REMARKS/ARGUMENTS

Amendments to the Drawings:

FIG.3

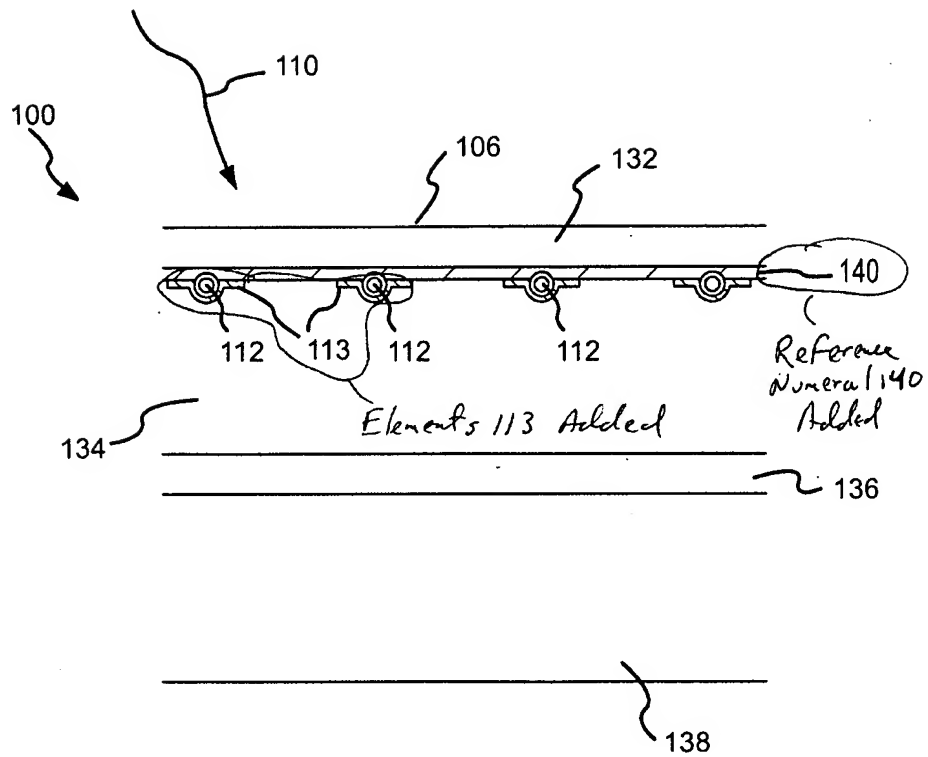
The attached sheets of drawings include changes to Figures 1 and 3. These sheets, which include Figures 1 and 3, replace the original sheets including Figures 1 and 3. In Figure 1, the previously omitted manual switch 121, microprocessor/controller 123, valve trigger/controller 125, valves 127, and temperature sensors 129 have been added. In Figure 3, the missing element number "140" and the omitted brackets 113 were added.
